# Maine Yankee

RA-05-019  
Proposed Change No. 218, Supplement 19

Subject: Response to NRC RAI on FSS Final Report Nos 1 and 2

## **Maine Yankee Response to NRC Request for Additional Information (RAI) Regarding Final Status Survey (FSS) Final Report Nos. 1 and 2**

Map#: FA1700-02 Date: 5/7/03 Time: 1600 Reactor Pwr %: N/A Tech File Number: 19.500.1 RWP's Used: NA Dose Received: 0 mR

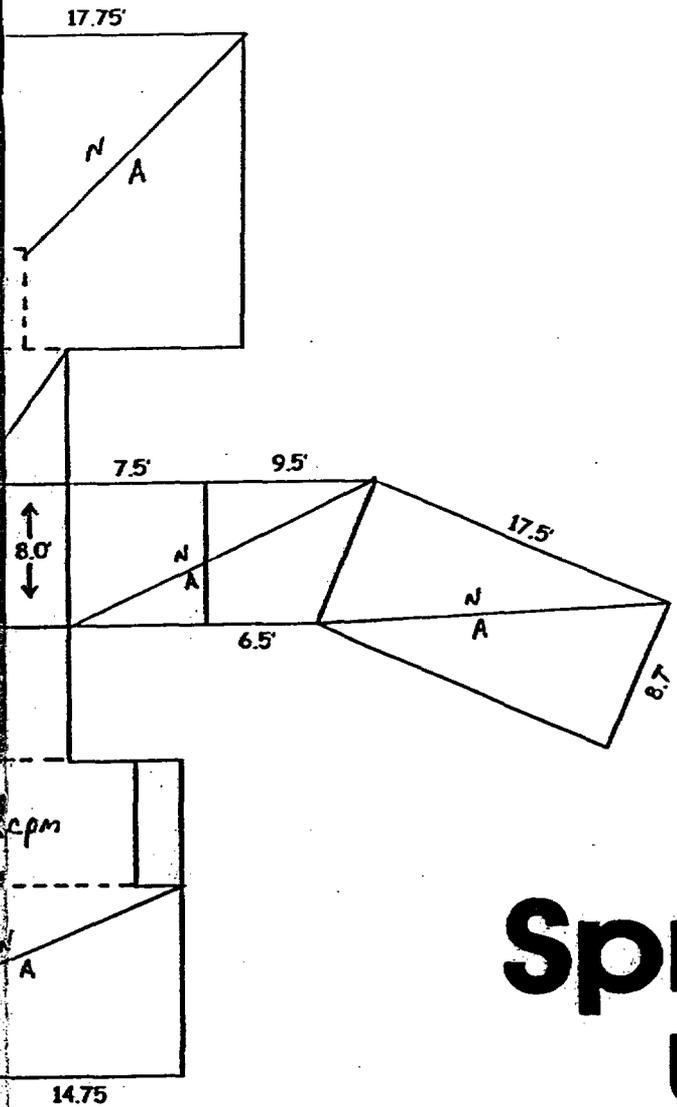
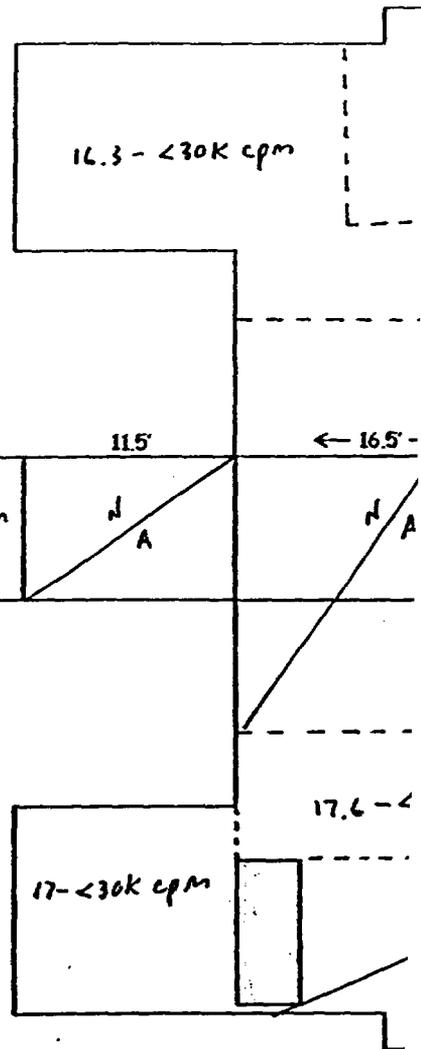
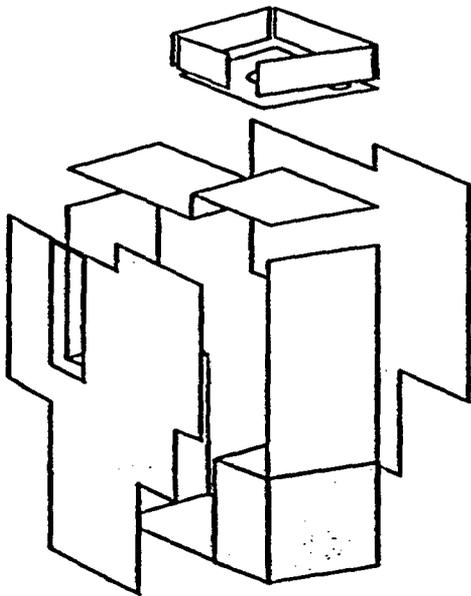
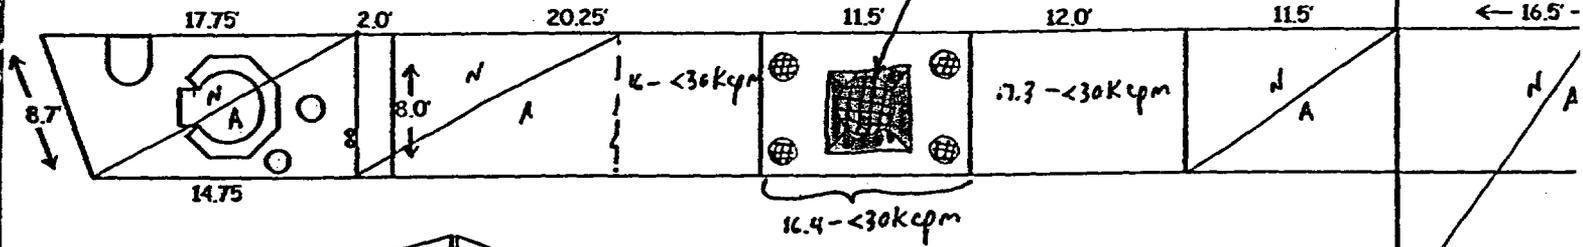
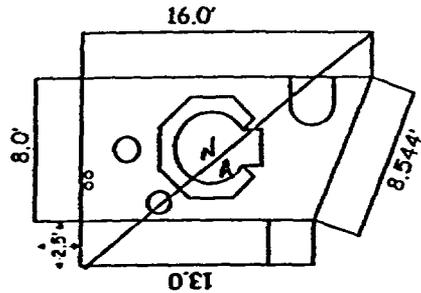
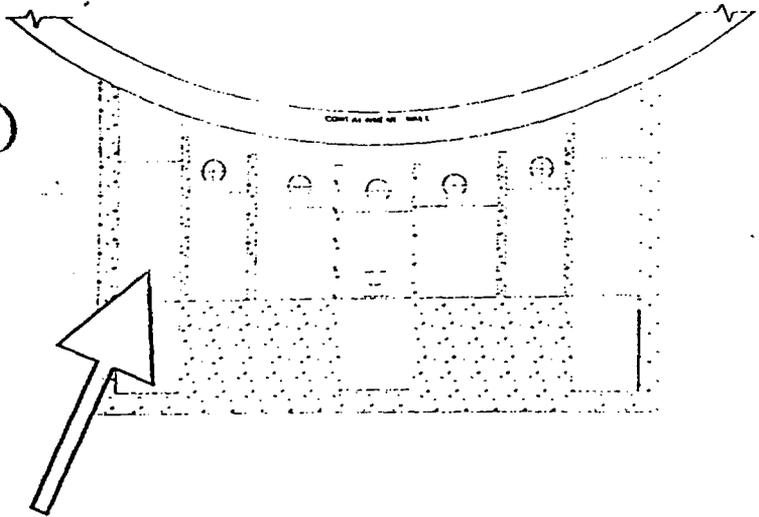
*Survey Unit 2 - Maine Yankee’s response does not indicate that gamma surveys were performed after the pump mount curb and RicWil pipes were removed. Please provide gamma survey data.*

Attached (Appendix A) are remediation survey gamma scan results of the concrete surrounding the Ric Wil pipe in Survey Unit No. 2 (interior Spray Building prior to Ric Wil pipe removal). Survey Map dated May 7, 2003 shows the Ric Wil pipe with elevated gamma readings (up to 900k cpm). Survey Map dated June 10, 2003 shows the Ric Wil pipe loaded with lead blankets to shield the radiation from contamination inside the pipe from the concrete surfaces around the pipe which were being surveyed. All of the remediation survey gamma scan results of the concrete surrounding the Ric Wil pipe penetration were less than 30 k cpm. This survey demonstrated that the elevated gamma results were due to the Ric Wil pipe not concrete around the Ric Wil pipe. The Ric Wil pipe was removed as part of the excavation associated with FR-0111 Survey Unit 3 as shown in Appendix B of Reference No. 22. FR-0111 Survey Unit 3 (Map FR0111U3-04), shows ISOCS measurements taken on the exterior Spray Building wall following Ric Wil pipe removal. Maine Yankee has not located a gamma scan result of the interior Spray Building wall following Ric Wil pipe removal.

**FINAL RAD REMEDIATION SURVEY**

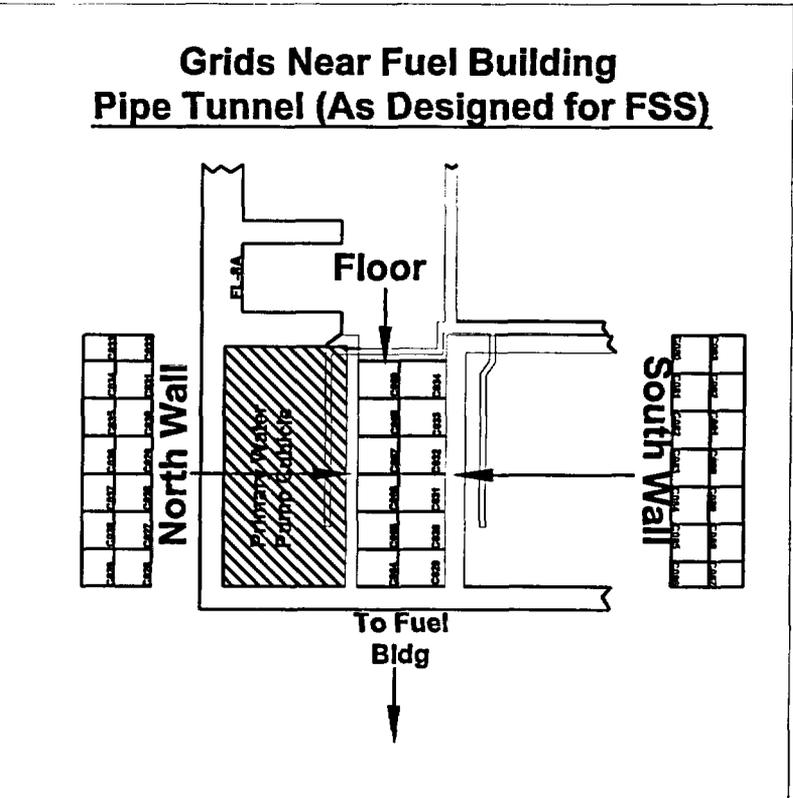
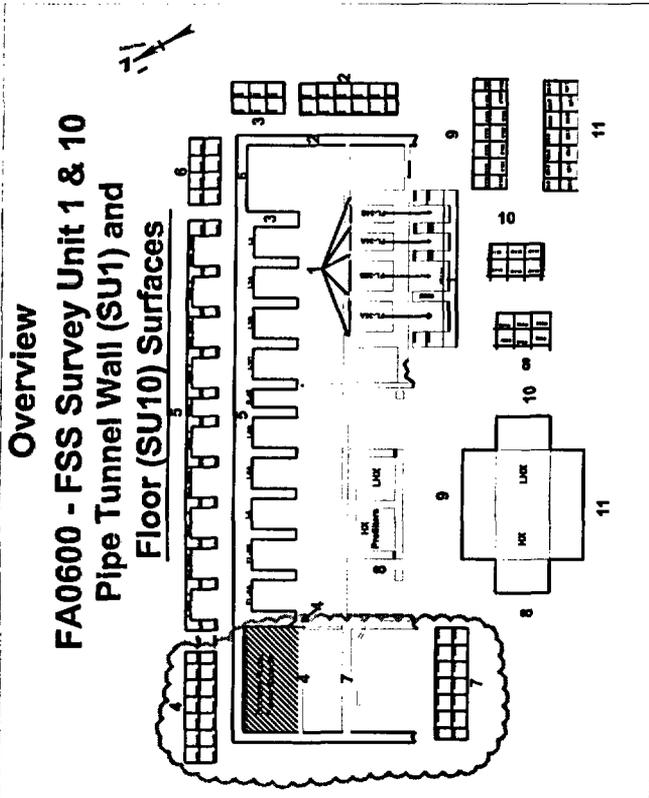
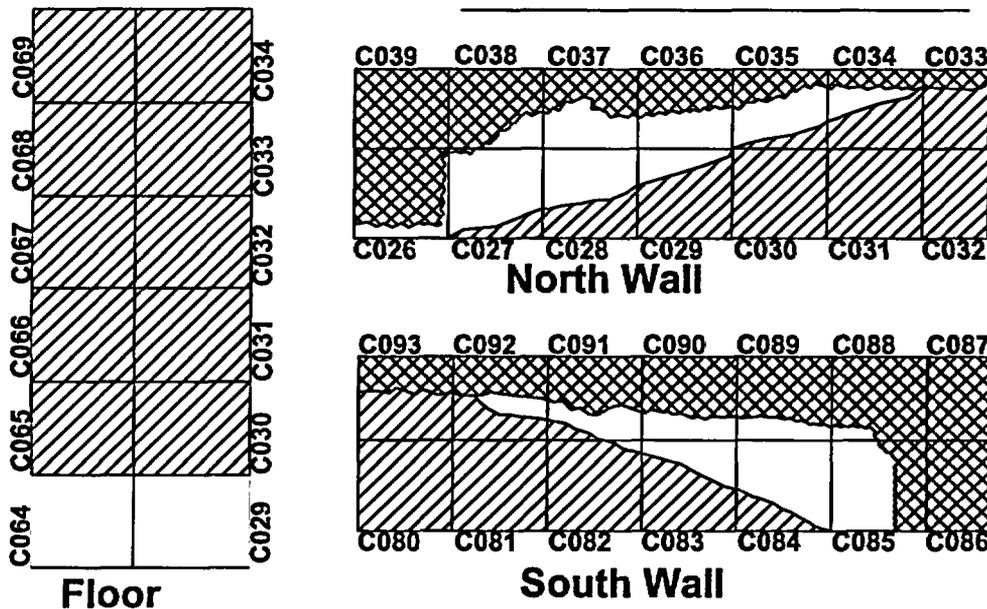
*PAB Survey Unit 1, Grids C039, C086, and C087: Maine Yankee's response states, "It was the surveyor's judgement that the reason the scan results were higher than the 30 K cpm gamma scan guideline was due to the shine from the fuel building not from the wall grids themselves... It was not possible to demonstrate that these wall grids met the 30 k cpm guideline without first removing the fuel building tunnel walls. The fuel Building tunnel walls are now being demolished and properly removed. In addition, Maine Yankee will also removed the PAB wall areas associated with wall grid nos C026, C039, C086 and C087 (Appendix J)."*

*"Surveyor's judgement" is not acceptable justification for the lack of survey data. Upon completion of the remediation activities, please provide the gamma scan data and revised FSS survey data for these areas.*

*PAB Survey Unit 10: Maine Yankee’s response states, “For the floor grid nos C029 and C064 it was the surveyor’s judgement that the reason the scan results were higher than the 30 k cpm gamma scan guideline was due to the shine from the fuel building not from the floor grids themselves... It was not possible to demonstrate that these floor grids met the 30 k cpm guideline without first removing the fuel building tunnel walls. The fuel Building tunnel walls are now being demolished and properly removed. In addition, Maine Yankee will also removed the PAB floor associated with floor grid nos C029 and C064 (Appendix J).”*

*Surveyor’s judgement” is not acceptable justification for the lack of survey data. Upon completion of the remediation activities, please provide the gamma scan data and revised FSS survey data for these areas.*

Maine Yankee is perplexed by the NRC's evaluation of our response to this RAI, since Maine Yankee discussed its plans to address the PAB concrete surfaces associated with the grids. Accordingly, attached (Appendix B) are the gamma scans of these concrete floors and walls (concrete wall grids have been almost completely removed).

Appendix J of Reference No. 22 included two photographs which showed the uncovered walls of the PAB which interface with the fuel building tunnel. These pictures were intended to show the current status of fuel building tunnel demolition up to the interface with the PAB and provide the NRC with confidence that Maine Yankee intended to uncover/demolish/survey the grids (SU 1 wall grid nos. C039, C086 and C087 and SU 10 floor grid nos. C029 and C213) which could not be surveyed because of the shine from the fuel building tunnel. Wall grid no. C038 (next to C038 - indicating that C039 had already been demolished) and wall grid no. C087 are shown on FSS-RR Map FA0600-01B. The last digit of wall grid no. C087 was defaced by the excavator. (There is no grid no. C08, since all grids have three digit numbers following the material designator...in this case "C" for concrete.) As indicated in the above Maine Yankee response to NRC Specific Comment on FSS Report No. 2 - Comment No. 2, the gamma scan results for the removed surfaces are provided in Appendix B.

**Comments:** Surveyed all remaining exposed concrete at the West end of the PAB pipe tunnel. No activity greater than background was found. The upper portion of the walls of SU1 have been demolished and no longer exist.
